ACTION TRANSMITTAL No. 2018-23

SUBJECT: Scope Change Request for Scott County's CSAH 21 / TH 13 Intersection Project

RE Scope Change Request
SP 070-621-032
CSAH 21 and TH 13

Scope Change Request CSAH 21 and TH 13 – FY 2020

FIGURE 1
PRELIMINARY DESIGN CONCEPT 1
SCOTT CO. C.S.A.H. 21 AT TH 13
2016 REGIONAL SOLICITATION
PRIOR LAKE, MN

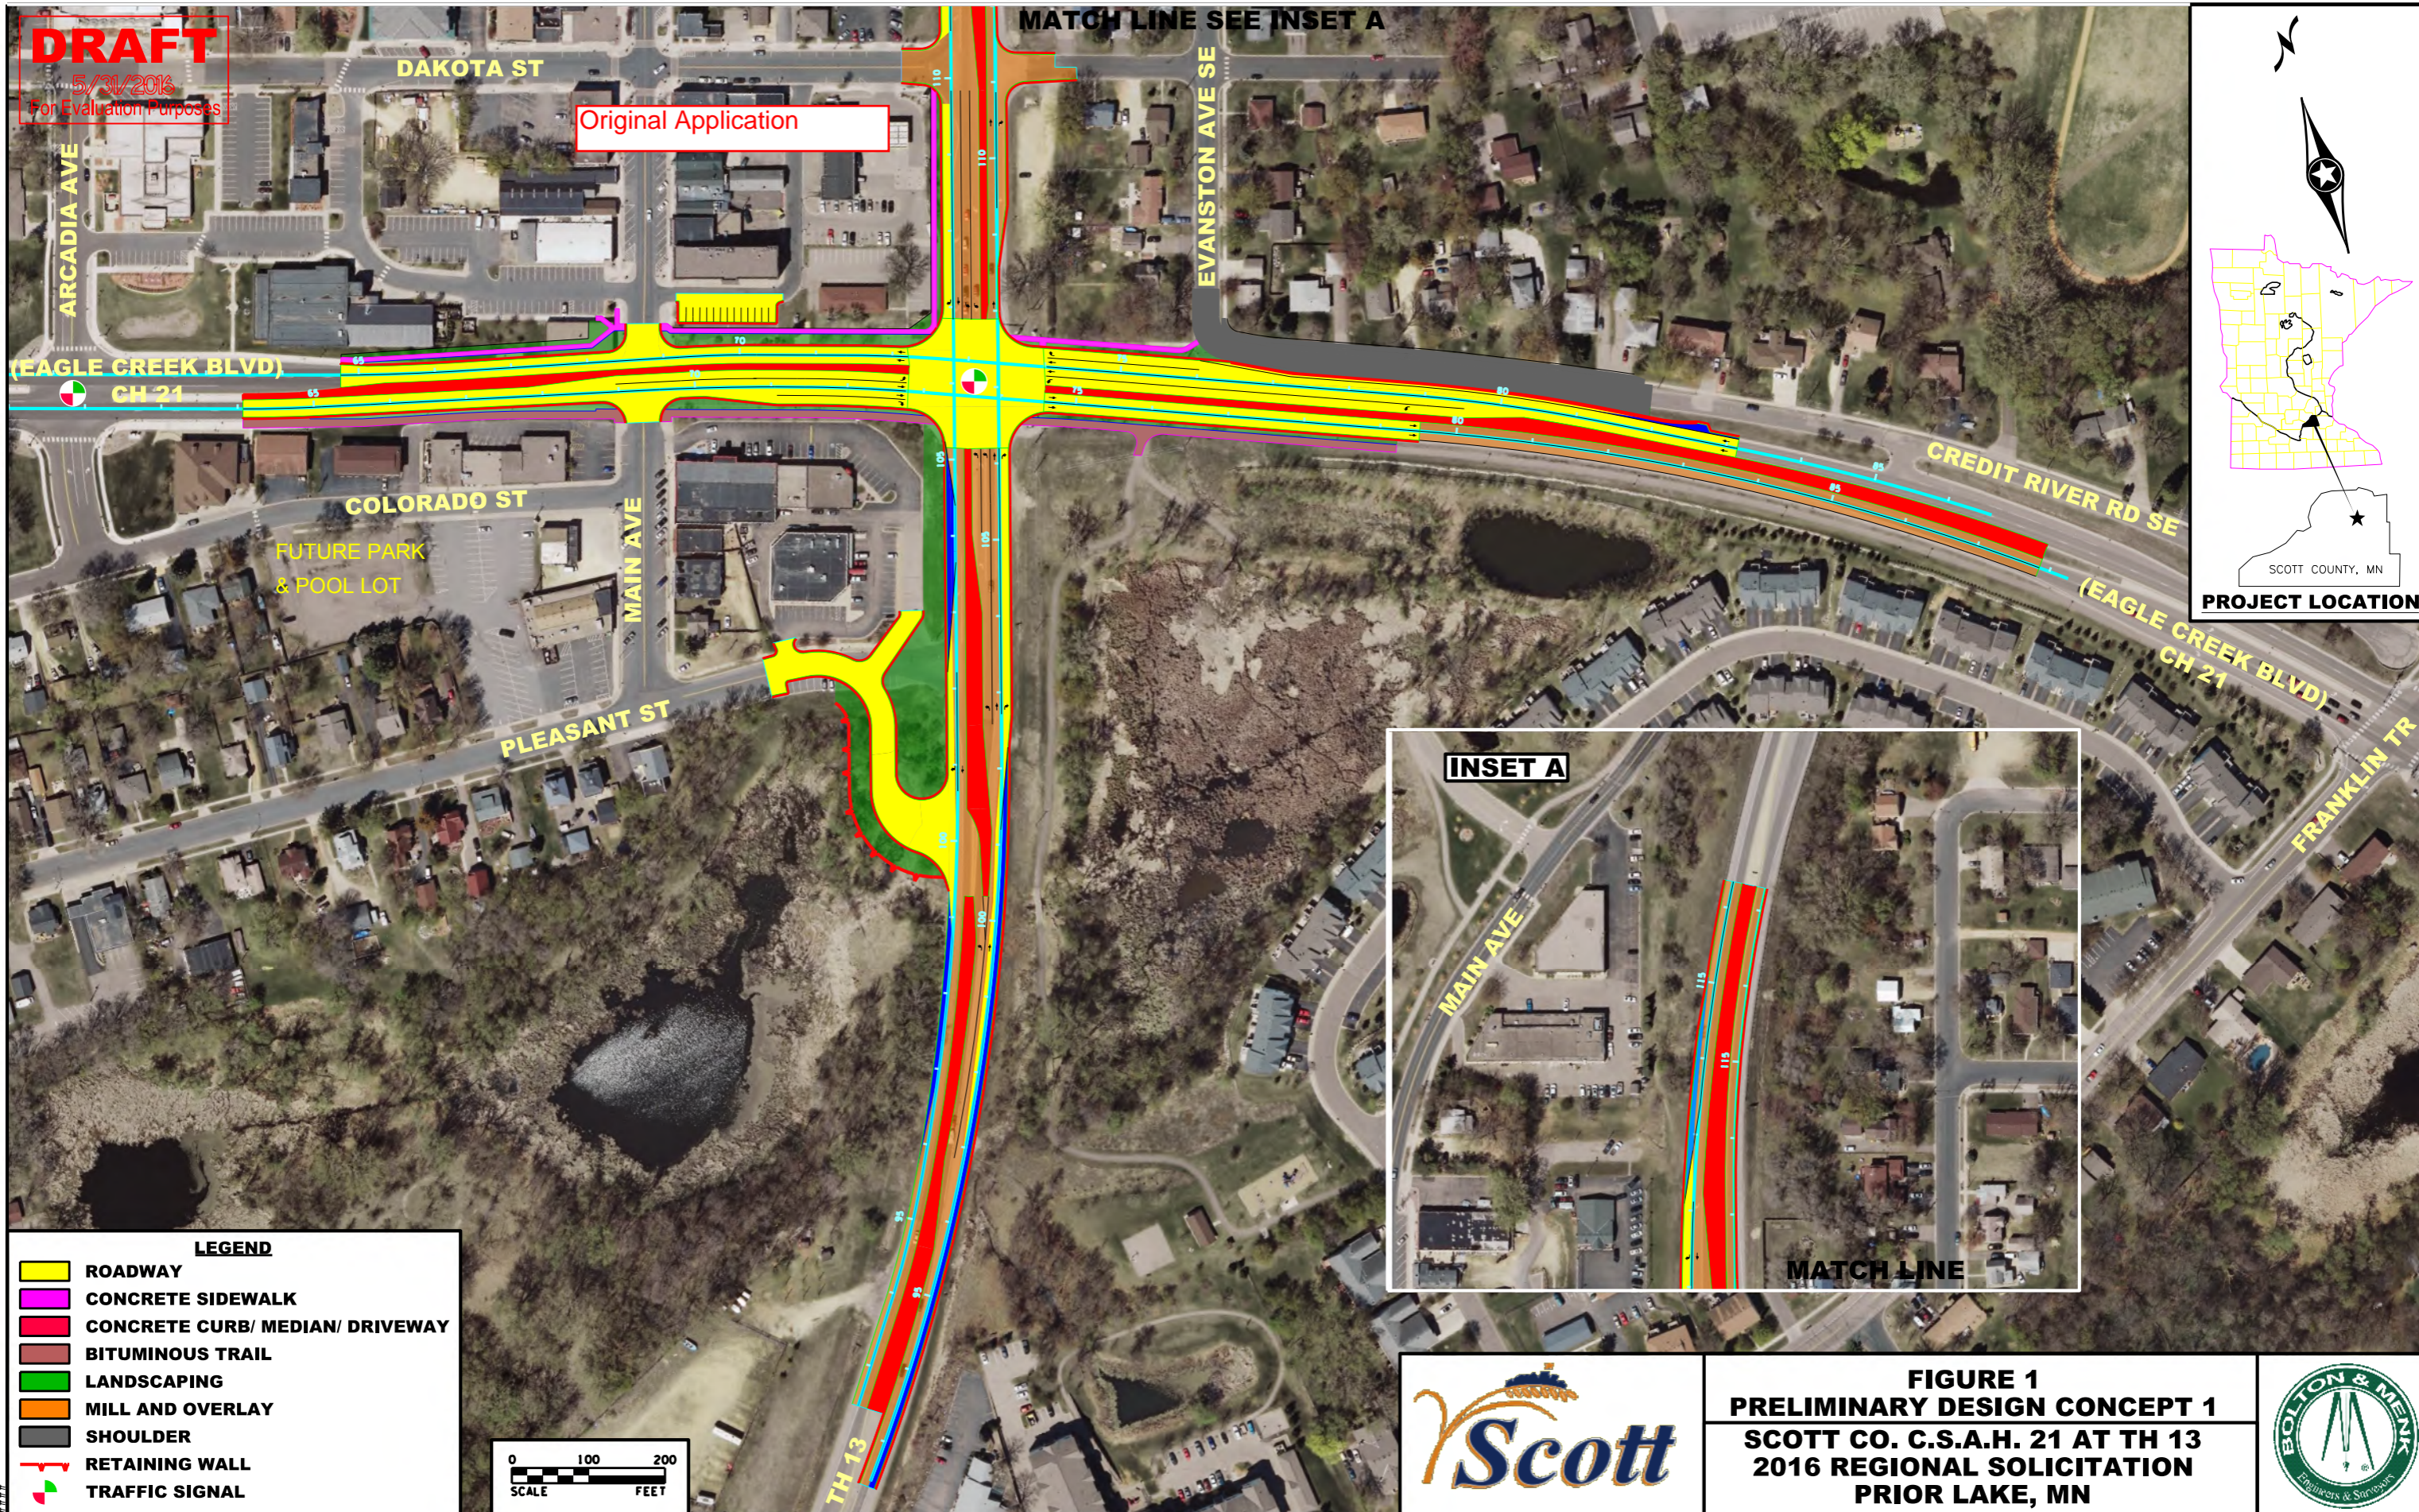
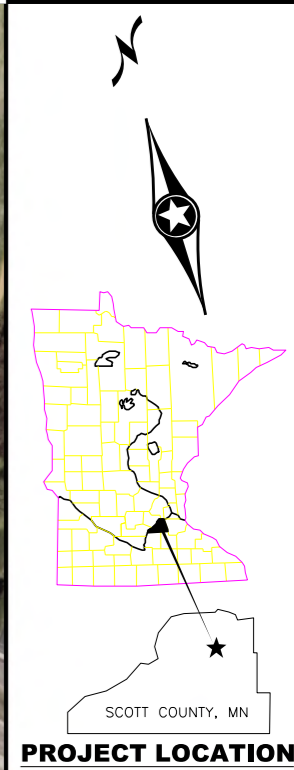
- Change the western limits from Arcadia Avenue to West Avenue to include pavement rehabilitation work and construction of a 3/4 access intersection at Duluth Avenue.
- Change the southern limits on TH 13 from Pleasant Avenue to Franklin Trail.
- Change the signal at CSAH 21 and Arcadia from a signal to a roundabout.
- Change the signal at CSAH 21 and TH 13 from a signal to a roundabout.
- Change the right-in/right-out at Main to a 3/4 intersection for northbound traffic on Main.

- Change the western limits from Arcadia to West Avenue to include pavement rehabilitation work and intersection at Duluth.
- Change the southern limits on TH 13 from Pleasant Avenue to Franklin Trail.
- Change the Signal at CSAH 21 and Arcadia from a signal to a roundabout.
- Change the Signal at CSAH 21 and TH 13 from a signal to a roundabout.
- Change the right-in/right-out at Main to a $\frac{3}{4}$ intersection for northbound traffic on Main.

RECONSTRUCT CSAH 21/TH 13 INTERSECTION IN PRIOR LAKE INCLUDING ON CSAH 21 FROM ~~ARCADIA~~ WEST AVE INTERSECTION TO FRANKLIN TRAIL E OF MN 13 - RECONSTRUCT INTERSECTION WITH MAIN AVE TO ~~RIGHT-IN/RIGHTOUT,~~ ^{3/4} INTERSECTION, ~~REPLACE/ADD TRAFFIC SIGNALS~~ ROUNDABOUTS AT TH 13 & ARCADIA AVE INTERSECTION, ^{3/4} INTERSECTION AT TH 13 & PLEASANT ST, TURN LANES, TRAIL/SIDEWALKS, PED AND TRANSIT AMENITIES
